RE: LAHC Matraville

Our Ref: 22-000279-LTR-CMA-2022-11-16

289-293 Beauchamp Rd, Matraville - Flood Advice Letter

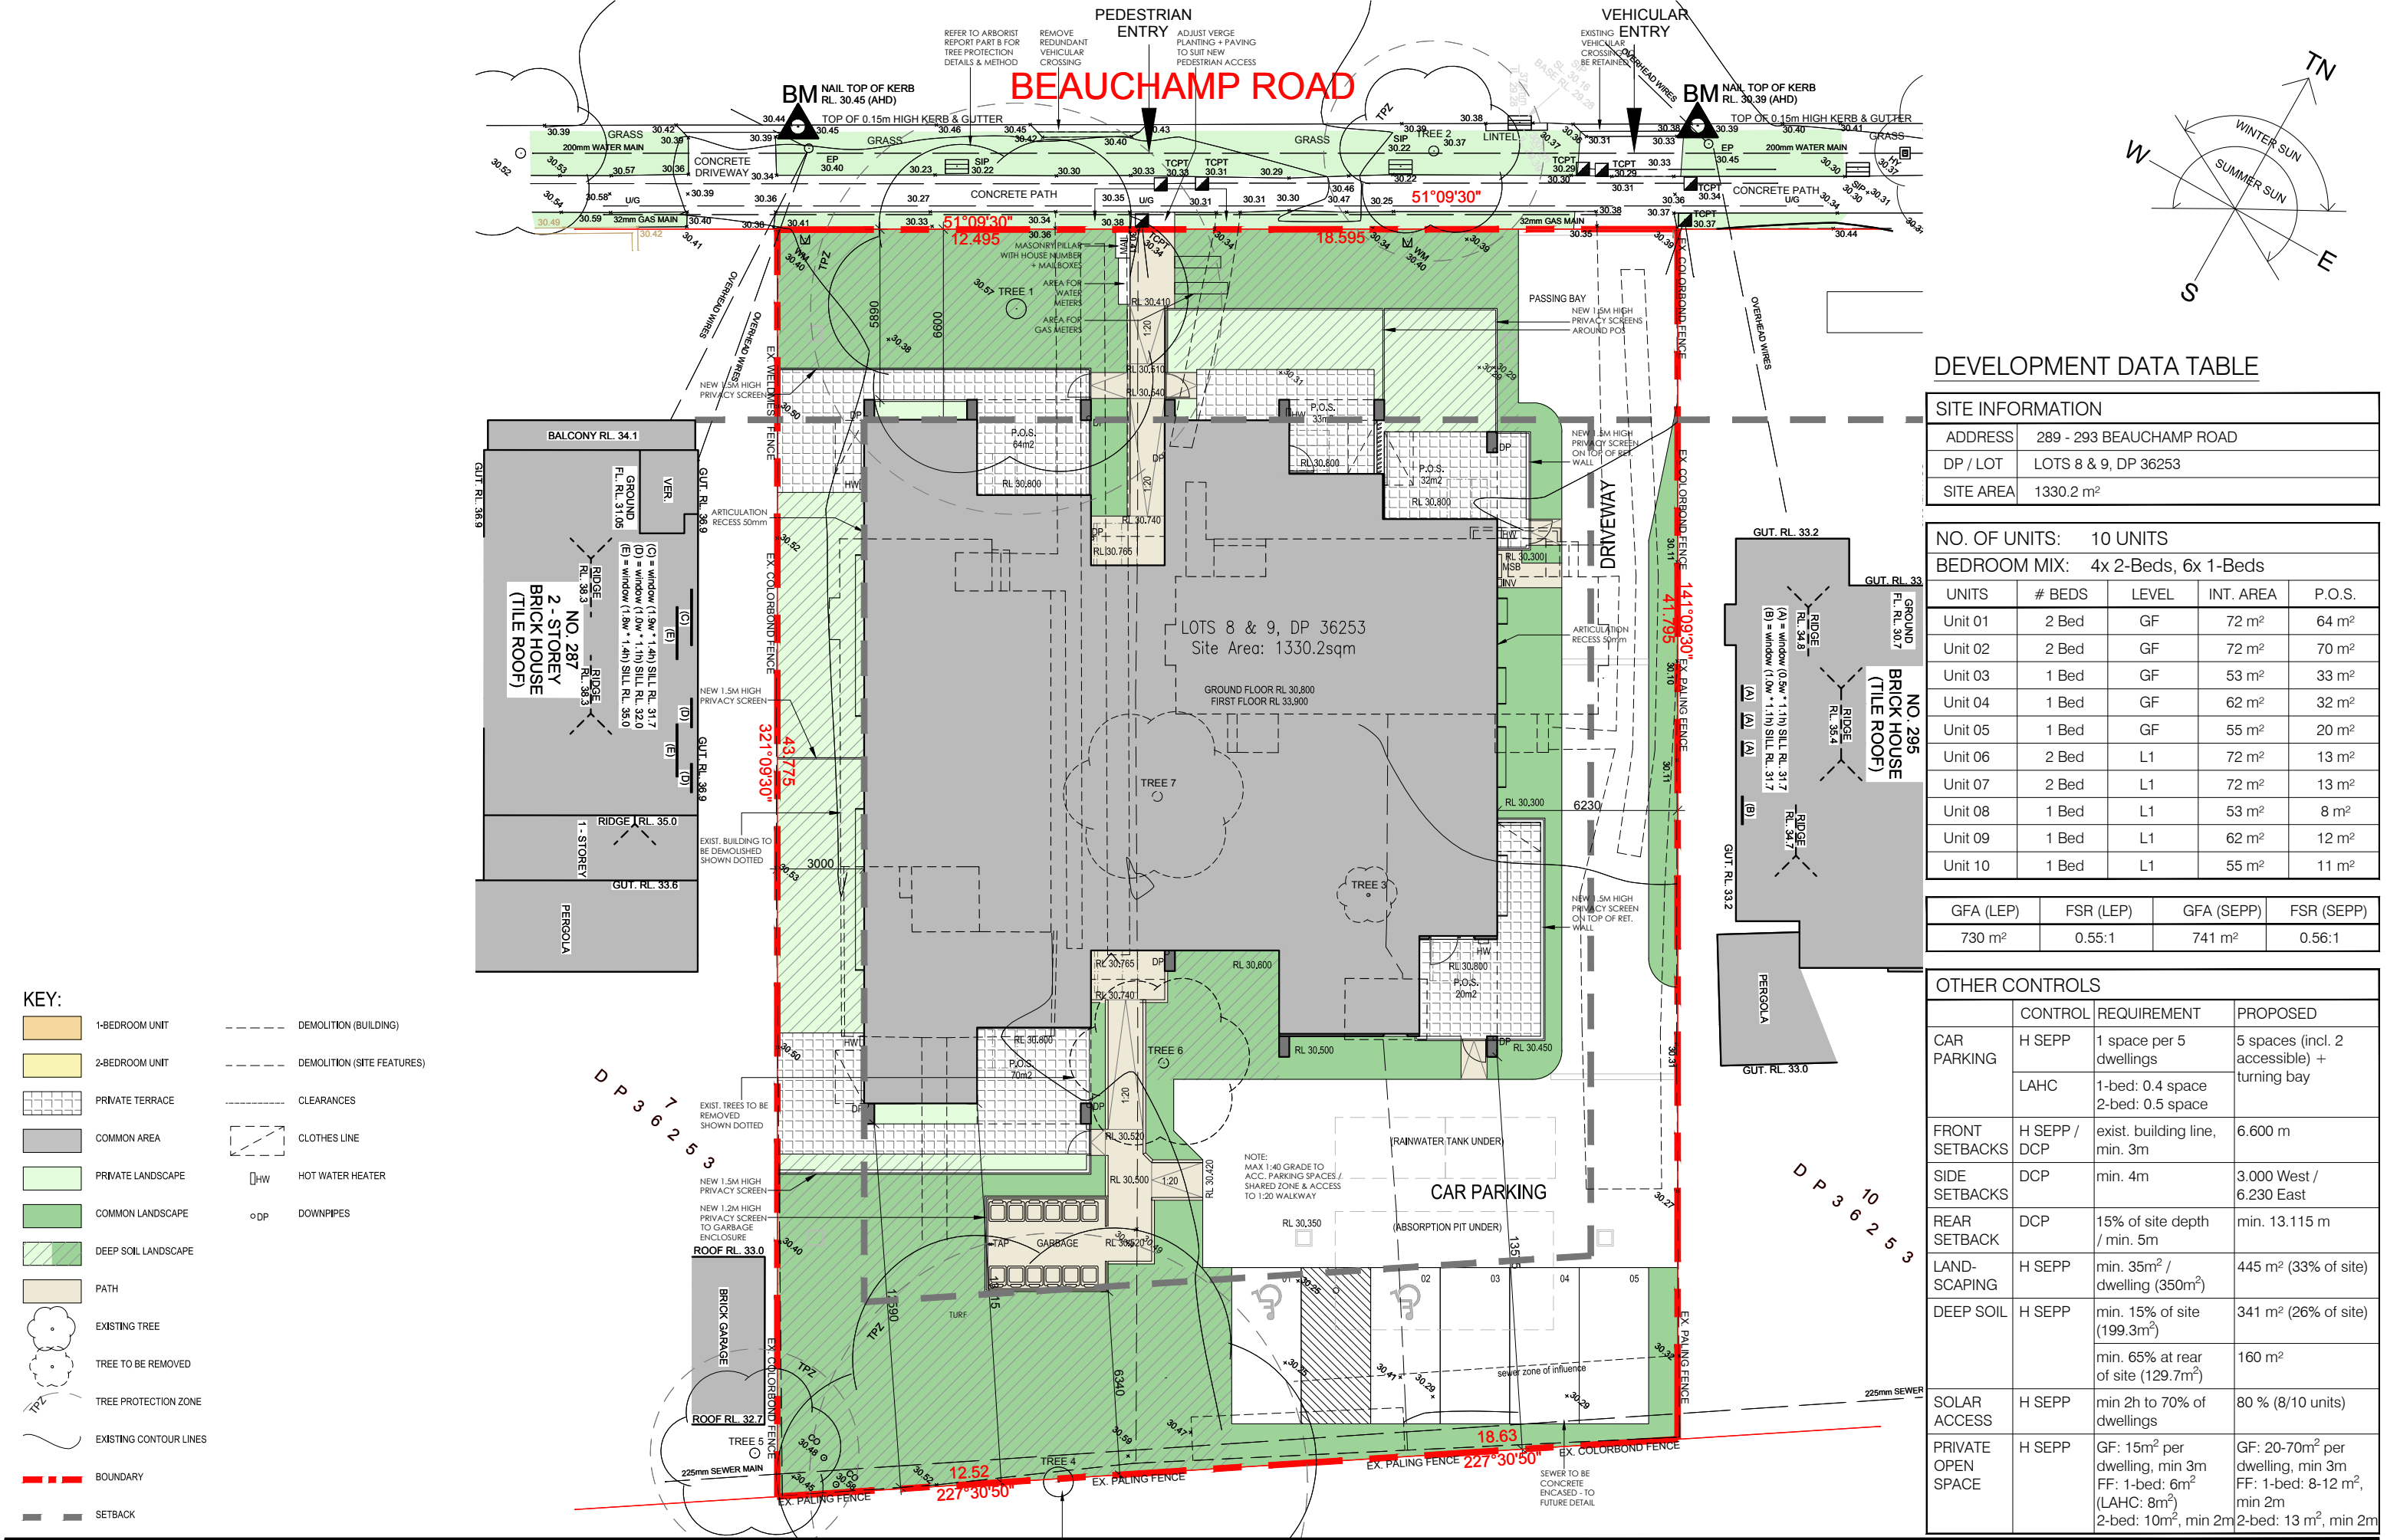
The flood advice letter from Council indicated that, based on the Council Flood Modelling, the site was flood affect to RL30.30. As can be seen in the image below the extent of this flooding is limited to some small, localised areas along the property frontage with Beauchamp Road.

The area of flooding that impacts on the site is associated with an existing stormwater pit in a low point of the footpath near the north east frontage of the site. This flooding is classified as low hazard and won't be impacted on by the proposed development. Low hazard flooded areas are defined in the NSW Floodplain Development Manual (NSW Government 2005) as "should it be necessary; truck could evacuate people and their possessions; able-bodied adults would have little difficulty in wading to safety."

The required floor levels for the building are to RL30.80 to provide the required 500mm freeboard.
